## Sol

REV D to E

The following is a complete list of changes necessary to modify a Revision D Sol to a Revision E Sol. These changes are illustrated in Figures A & B for your convenience:

Figure A

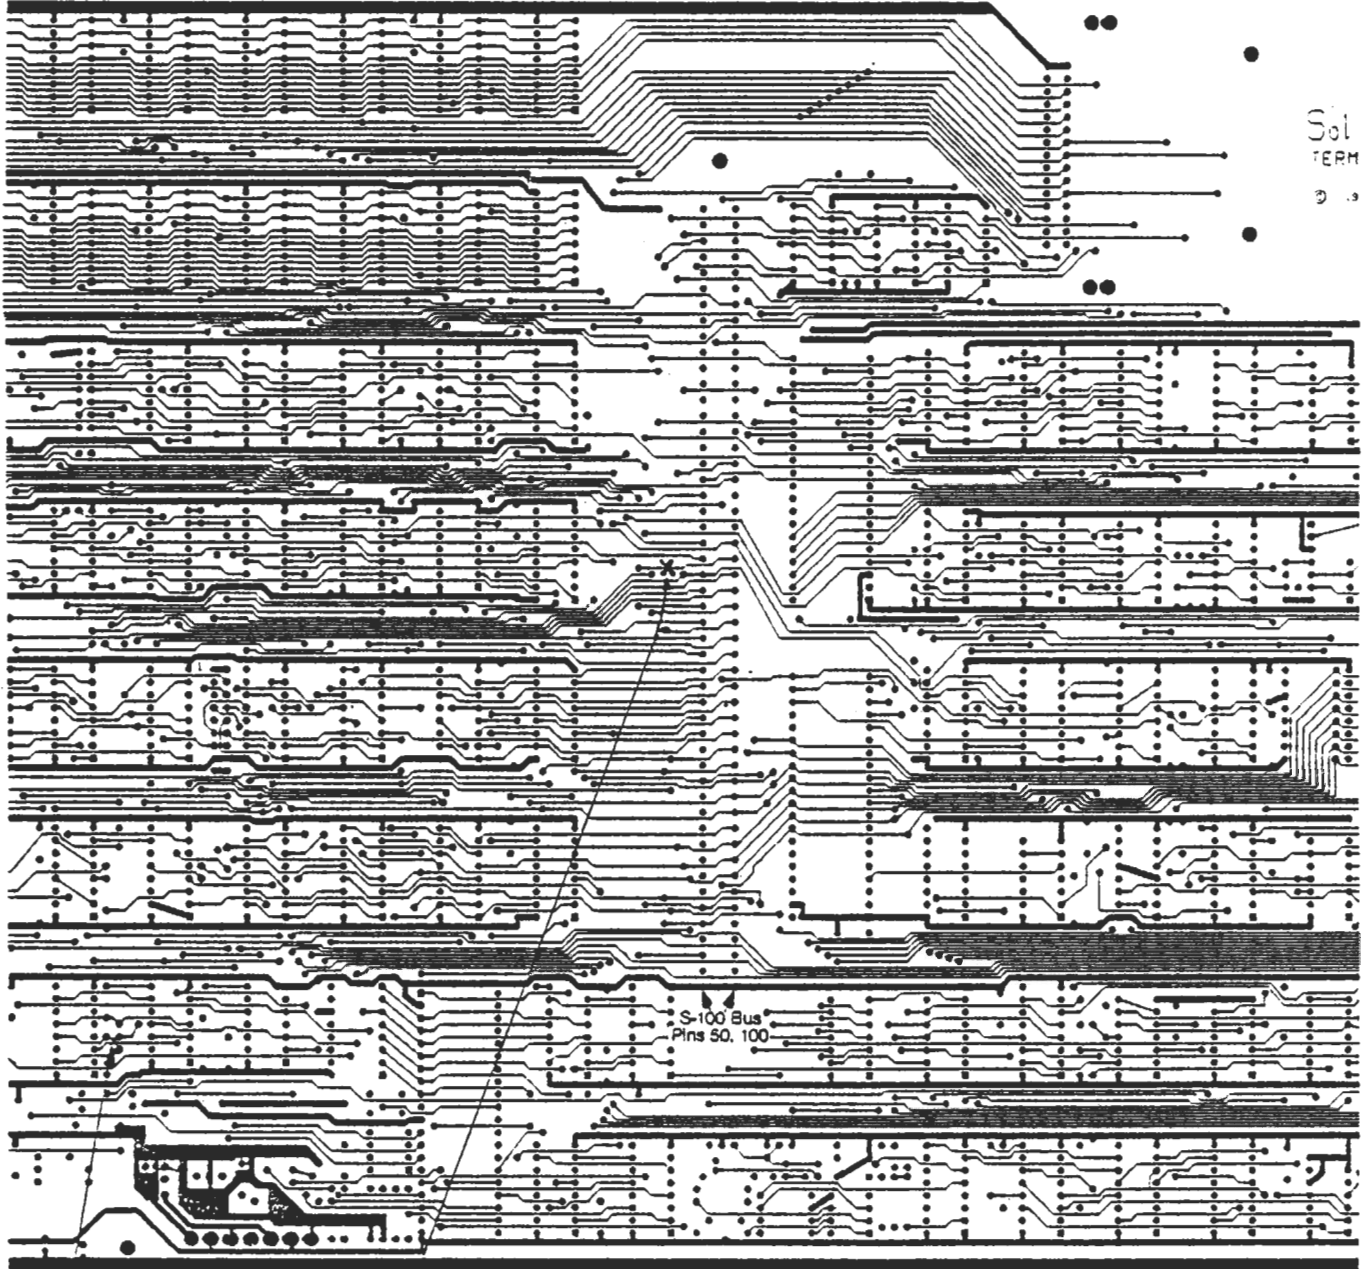
On component side of Sol PCB, cut the trace between jumpers D and E (U90 and U91) of the clock generator. On the solder side of the PCB, connect a jumper from pin E to the feedthrough which leads to U91 pin 5. This brings PHASE 1 into 8080 spec at 140 ns rather than 70 ns without this mod.

On the solder side of the PCB, connect a jumper from U76 pin 4 to the feedthrough immediately below U76 pin 1. This assures the Sol will always power up with 4 PHANTOM cycles.

On the solder side of the PCB, jumper pin 8 of U33, U50, U68 and U81 to the ground feedthrough leading to C45. Use 20 gauge insulated solid wire and keep the leads as short as possible. The fix shortens the return path to ground from the bus drivers. On occasion the present return path can be quite noisy.

On the solder side of the PCB, connect a jumper from the ground side of C11 to pin 70 of the 100-pin bus connector J11. This will ground the PROTECT line which is currently floating. Again, use 20 gauge insulated solid wire.

On the component side of the PCB, cut the trace leading to pin 73 of J11 (S100 connector). Cut the trace leading to pin 1 of U45 on the solder side of the PCB. Also on the solder side, cut the second trace to the right of U64.

Jumper pin 73 of J11 to pin 1 of U45. Jumper from pin 28 of J11 to the feedthrough which formerly led to pin 73 of J11 before the trace was cut. Jumper the feedthrough directly below pin 1 of U45 to the feedthrough to the right of U64 pin 3. This fix will allow the Sol to be used with DMA devices. Helios II, and other DMA devices will not work without this fix.

On the solder side of the PCB, cut the trace leading to pin 7 of U93. On the solder side, cut the trace leading to the feedthrough immediately below pin 1 of U92. DO NOT CUT THE TRACE LEADING TO U92 PIN 1!! Connect a jumper from this feedthrough to pin 13 of U107.

On the solder side, jumper the feedthrough leading to U94 pin 9 to the trace which formerly led to U94 pin 7 before the trace cut. This fix decodes the MWRITE signal from SOUT and PWR even when a DMA device has disabled the Status Drivers. This is especially important to memory boards which require MWRITE and do not decode PWR and SOUT internally and DMA devices (such as Helios) which do not supply their own MWRITE to the bus.

Sol-PC (Rev. D)—Solder Side  
Figure B

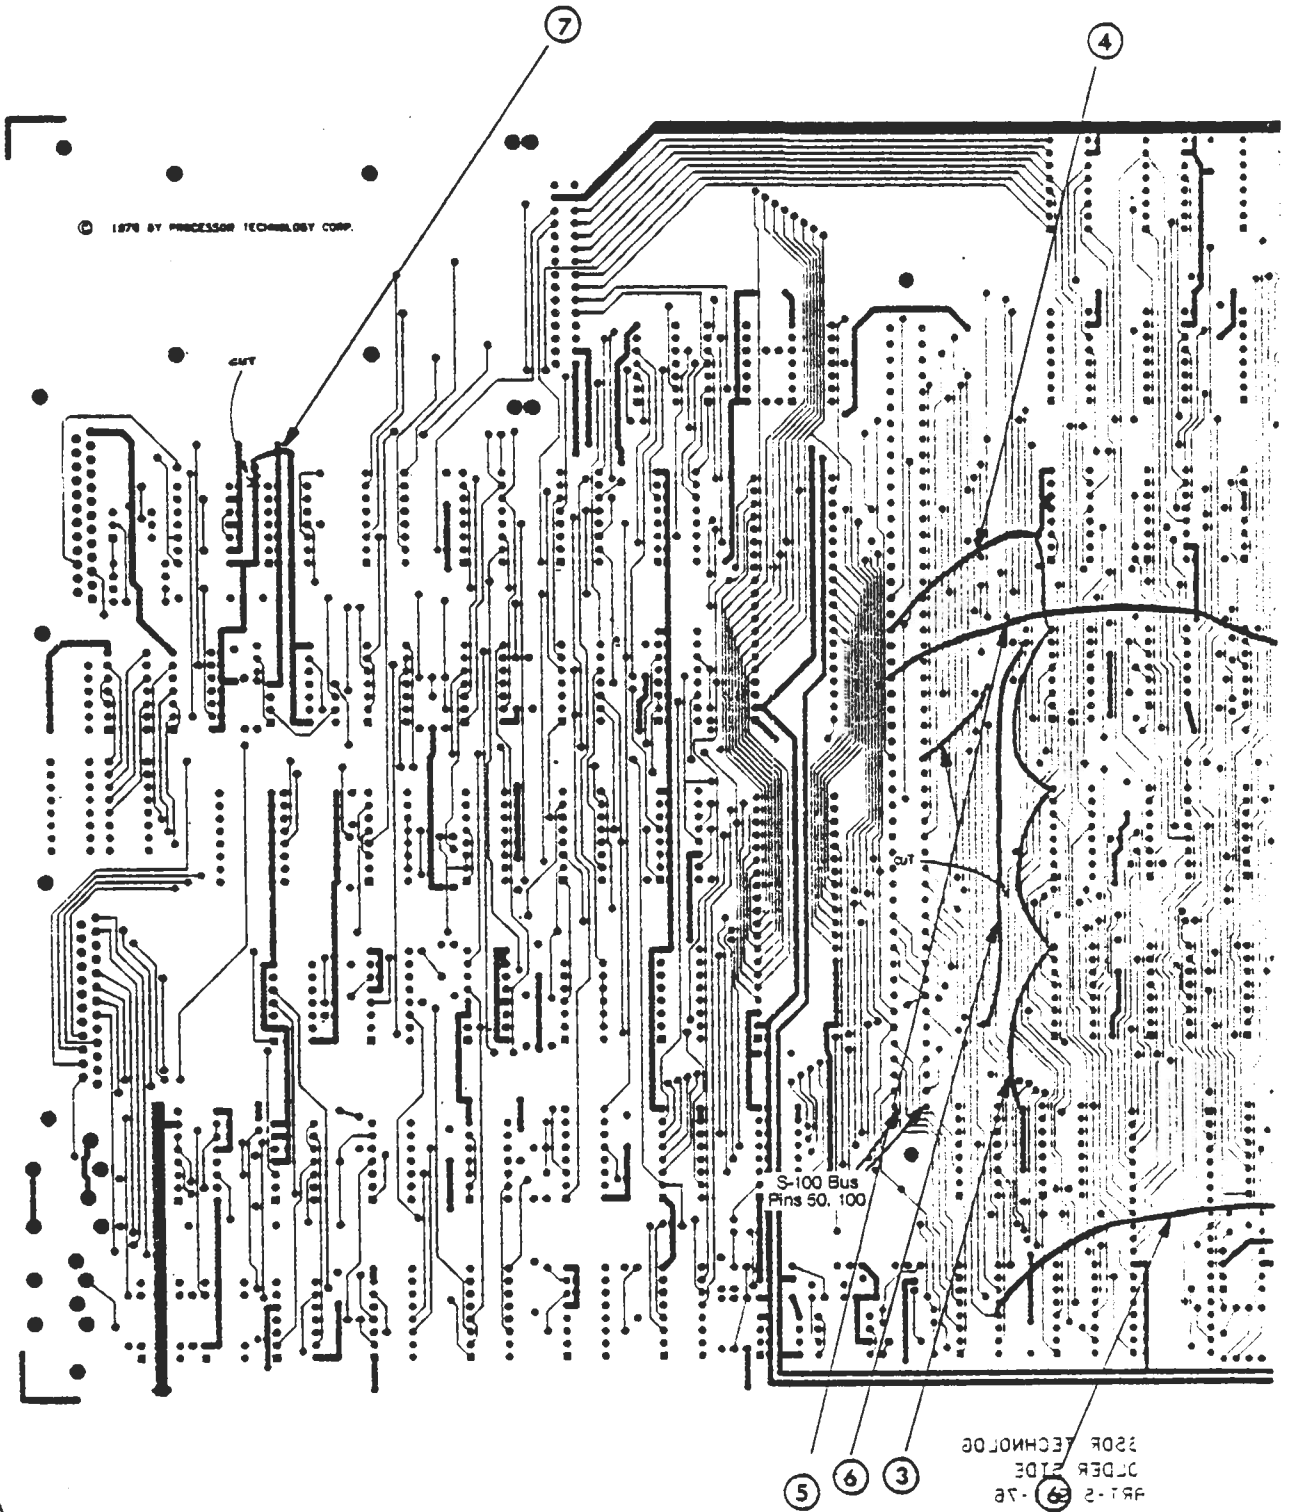
Cut the large trace which leads to R23 and R24 on the solder side of the PCB. Connect the now isolated end of R23 to the +12 Volt feedthrough as shown in Figure B.

On component side of Sol PCB, cut the trace leading to the hot lead of J9. On the solder side connect a 6.8 ohm, 1/4 watt (5%) resistor between the hot pin of J9 and cathode (banded end) of D14. Also on the solder side, cut the trace leading to the hot pin of J8 to the feedthrough isolated by the trace cut. This change is adding a series resistance to the cassette drive jack to limit the amount of current drawn by the cassette motor from the reed relays. Certain models of cassettes might draw excessive current and burn out the relays without this fix.

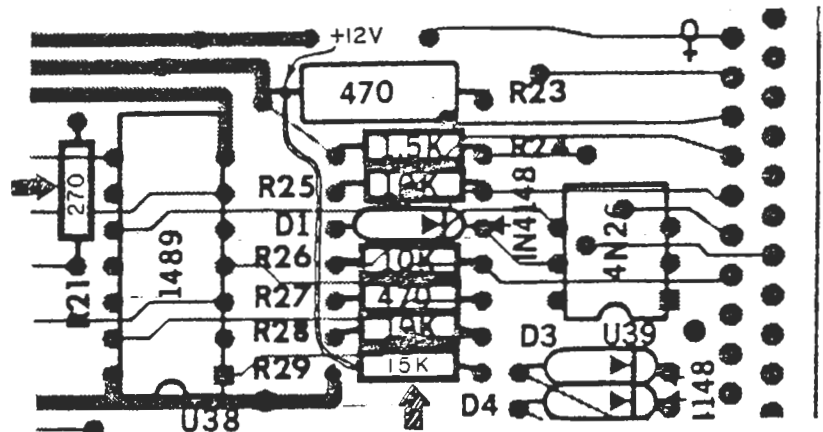
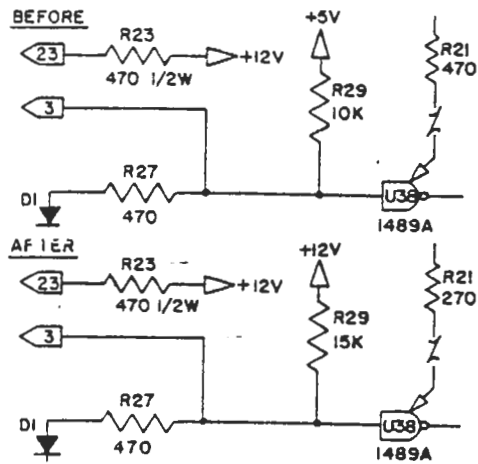
1. Substitute a 270 ohm, 1/4 watt (5%) resistor for R21 (formerly a 470 ohm resistor).

This change is to increase the drive capability of the serial current loop and was elaborated in CHANGE NOTICE #10.

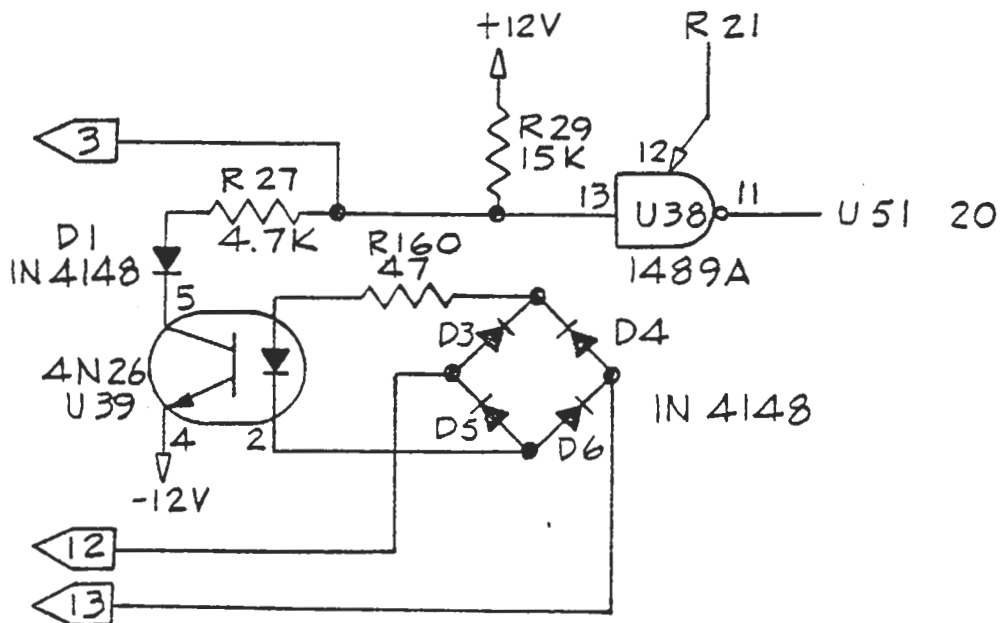
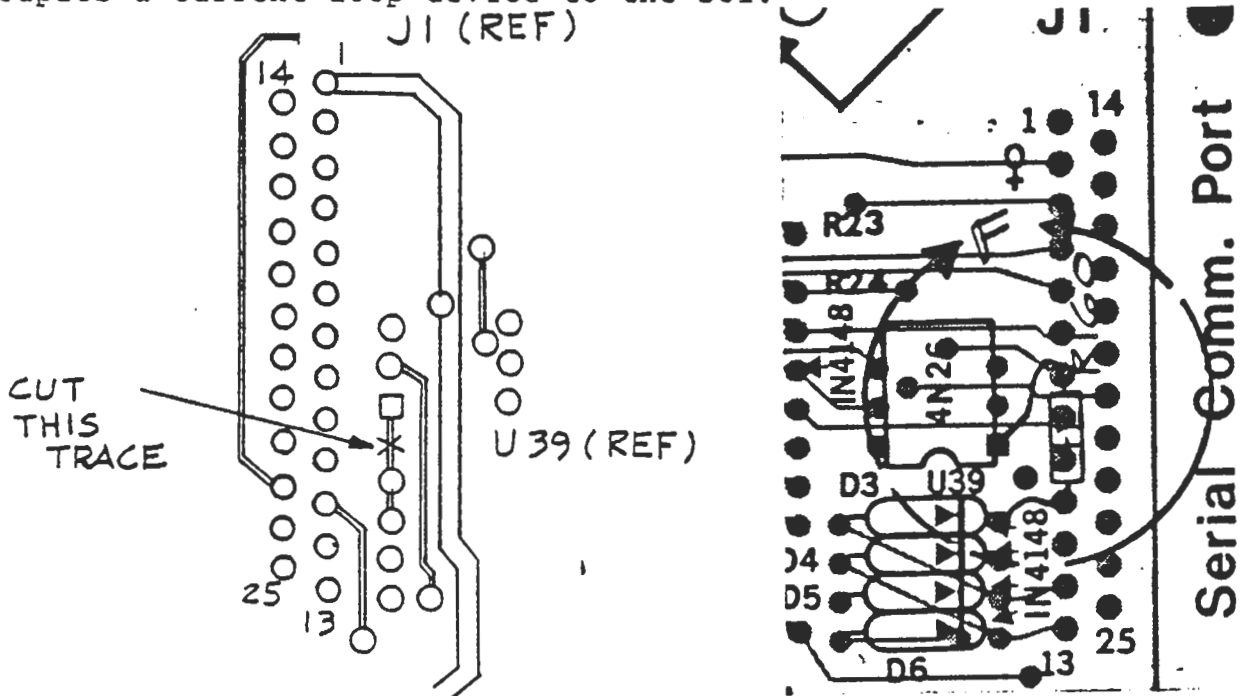
1. Change the value of R27 from 470 ohms to 4.7K ohms.
2. On the solder side of the PCB, cut the trace connecting U39 pin 1 to the cathode of D3. Check with an ohmmeter to be sure the cut is complete.
3. Wrap one lead of R160 (47 ohm resistor) around pin 1 of U39 (4N26) and wrap the other end around the cathode end of D3 (band side of 1N4148). Solder both leads of R160 and check for possible shorts.

This change was to enhance the reliability of the opto-isolator which couples a current loop device to the Sol.

Reference Section X, Drawing X-23.

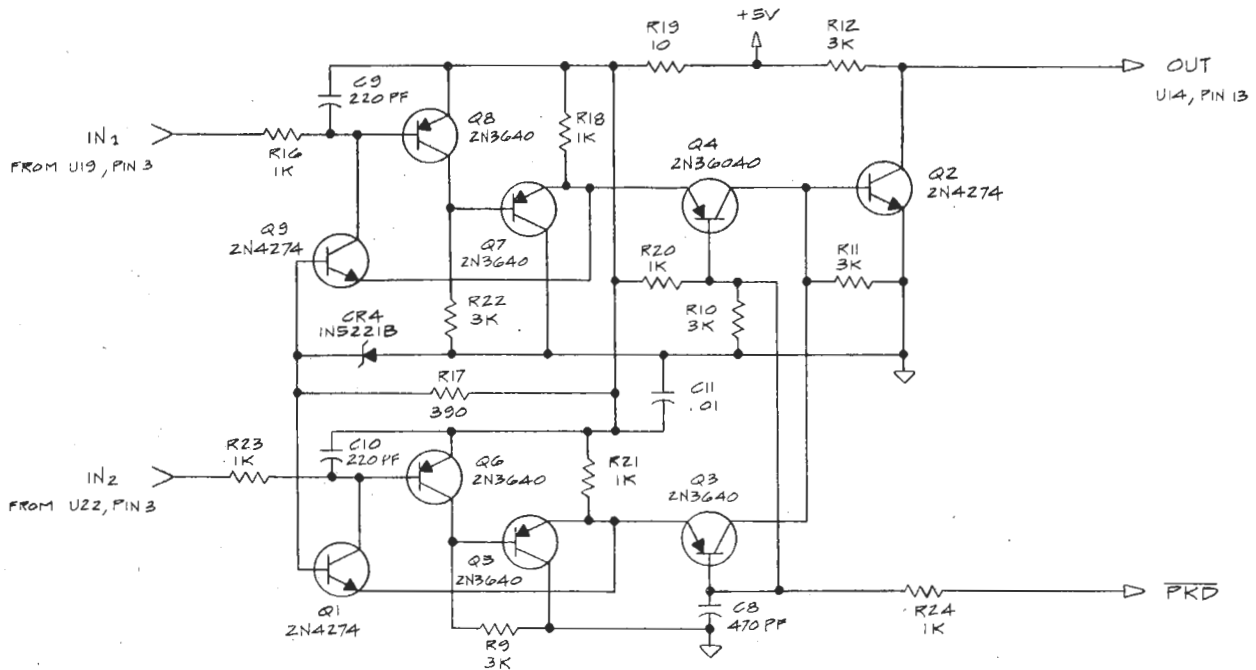
A block function labelled "K.T.C." is shown between U-19 and U22, and U14. This block contains the Capacitive Switch Detector Circuit. The parts constituting this circuit are listed, and the assembly covered in Section V of this manual. The theory of operation is covered in Section VIII. At the time of publication of this manual, operation of this circuit was proprietary information, but has now been released. The schematic is shown below. Note on the schematic X-23 that this detail is shown here on this page.

## ASSEMBLY PROCEDURE CHANGE NOTICE #6-2 Rev B

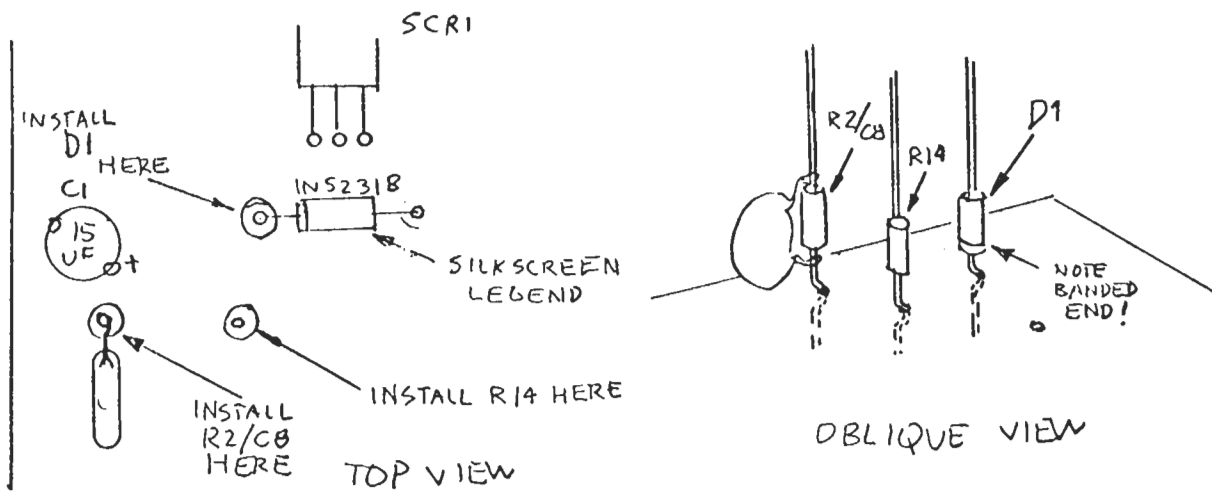
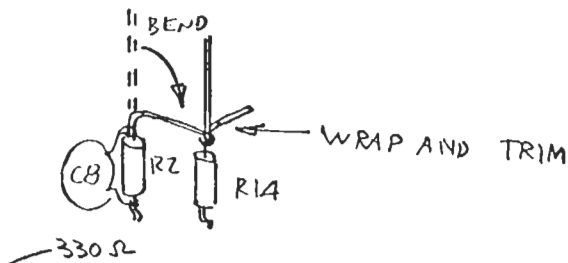
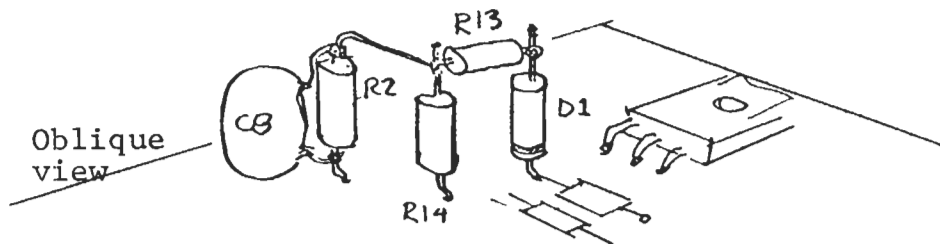
A problem was detected in early Sol-REG boards in which the "crow-bar" circuit would trigger without adequate cause and short circuit the 5-volt output. A circuit change has been made which will be reflected in Revision Level C and above boards to correct the problem. Revision Level B boards, however, require the following modification to correct the problem. Parts for this modification are supplied with your kit:

2. Solder C8 in parallel with R2 as shown:

3. Install and solder R2-C8, R14, and D1 as shown below. Install the formed leads into the board with the unformed leads vertical. Position R2-C8 so that the body of C8 is parallel to the board edge and oriented away from C1.

4. Bend the top lead of R2-C8 over towards R14, and bend it around the top lead of R14 one-eighth inch from the body of R14. Solder, and trim the excess lead of R2-C8 only.

5. Install R13 between the top leads of D1 and R14. Wrap R13's leads around R14 and D1 leads. Solder all connections at both points, and trim excess lead lengths. The resulting final configuration is shown below.

### ASSEMBLY PROCEDURE CHANGE NOTICE #6-2 REV C

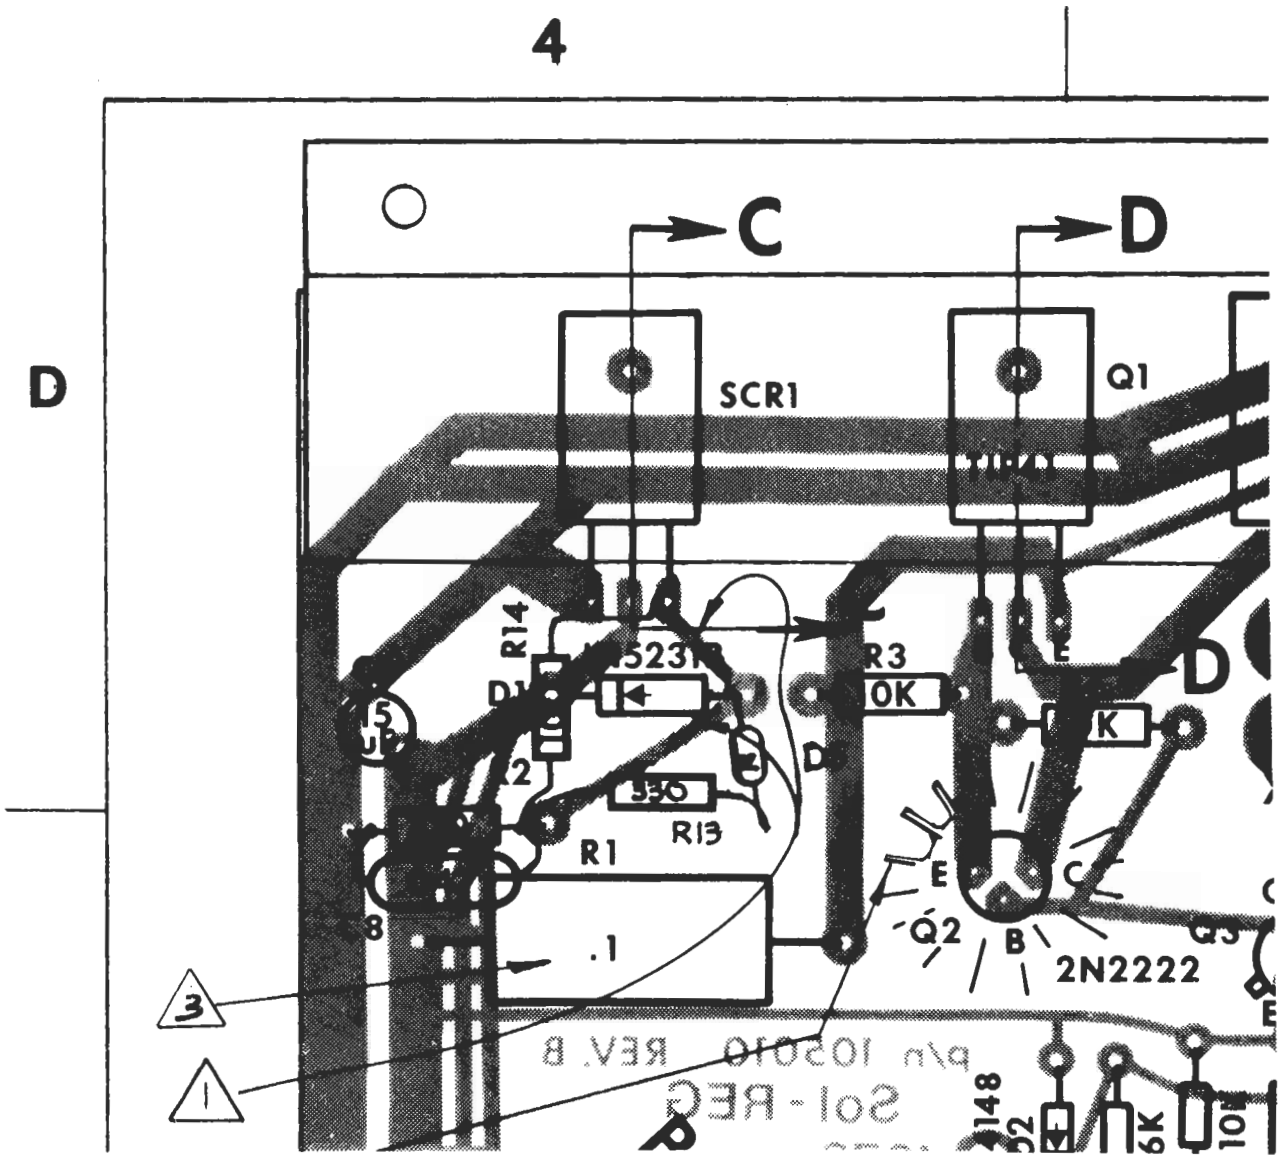
To enhance the reliability of the crowbar circuit which protects circuitry from overvoltage on the +5 volt supply, add the following additional parts, supplied with your kit, to Sol-Reg. Use the procedures given below after completing Step 13 of Section II, Sol Power Supply Assembly and Test. Make a note in your manual after Step 13 to remind you to do the additional steps below. Refer to the drawing on the next page as you add the parts to Sol-Reg.

( ) Step 1. Pass the two leads of C8 under the two leads of R2 (330 ohms) and bend around the leads of C8, close to the body of the resistor. Solder and trim the leads.

( ) Step 2. Wrap the leads of R14 around the right-hand leads of SCR1 and R2 (330 ohms), dressing the leads as shown in the drawing. Make sure the leads of R14 do not short to other leads of SCR1 or D1. Solder the lead to SCR1, but not the lead to R2 (330 ohms).

( ) Step 3. Wrap one lead of R13 (330 ohms) around the same right-hand lead of R2 (330 ohms), with the position of R13 parallel to D1 (1N5231B) as shown below. Solder the two leads which are wrapped around R2.

( ) Step 4. Wrap the leads of D5 (1N270) around the anode end (opposite banded end) of D1, and the loose end of R13 (330 ohms). Make sure the cathode (banded end) lead of D5 is connected to R13, not D1. Solder both ends of D5.
